Memo:

Date: February 1, 2019 – Revised- February 19, 2019 / **Revised March 6, 2019**
To: Olivia Glantz
From: Mark B. Ferris
Re: Wren Heights (Salem Heights) Subdivision - #18-125034-LD

RESPONSE TO LETTER OF INCOMPLETENESS – JANUARY 14, 2019 / Email Dated 2/11/19

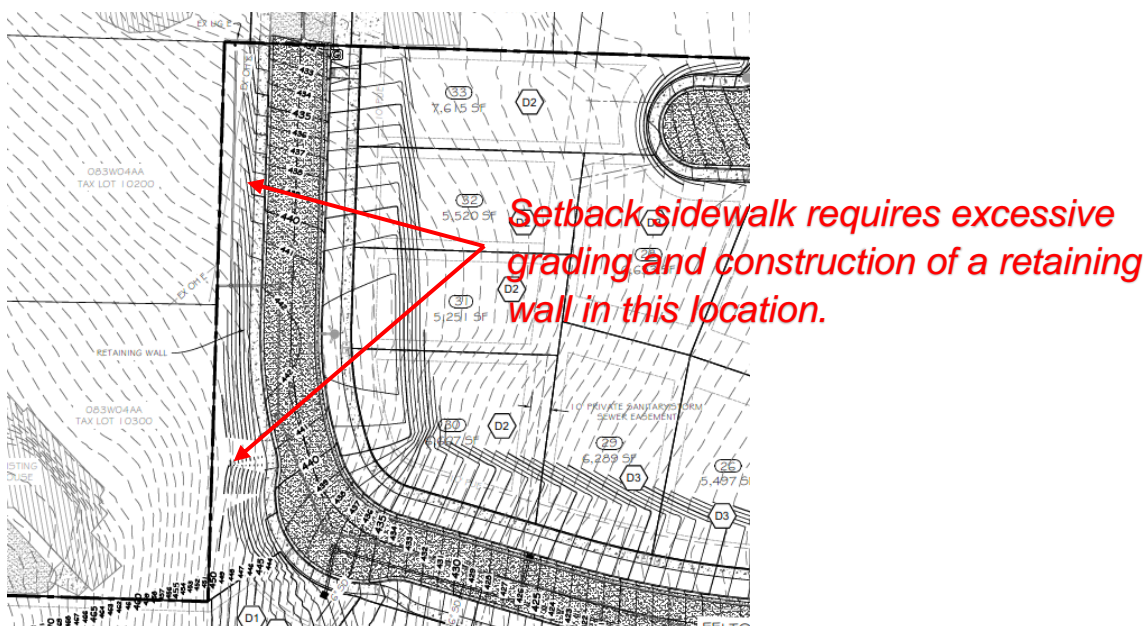
Applicant's Response: Pursuant to Section 803.065, the Applicant is requesting the Planning Director's approval of a curb-tight sidewalk adjacent to Tax Lots 10200 and 10300. Given the topography of the area adjacent these lots, providing a setback sidewalk has significantly more impact on these lots and requires the construction of a retaining wall to accommodate the elevation difference. Requiring a setback sidewalk and constructing a retaining wall at this location is definitely a less desirable alternative than keeping the sidewalk curb-tight and minimizing grading and construction impacts on the adjacent lots. For these reasons, the Applicant respectfully requests the director's concurrence.

SRC 803.035(1)(2)(B) If topography or other conditions make the construction of a sidewalk impossible or undesirable in a location required by this subsection, a different location may be allowed.

Applicant's Response: As previously stated, the Applicant is requesting a curb-tight sidewalk adjacent to lots 10200 and 10300. The example below clearly shows that there would be significantly more impacts to the adjacent property requiring the construction of a retaining wall in order to accommodate a setback sidewalk. Pursuant to this section, a different location may be allowed by the planning director if the topography makes building a setback sidewalk undesirable. Allowing the curb-tight sidewalk minimizes impacts to these lots. This requirement is met.
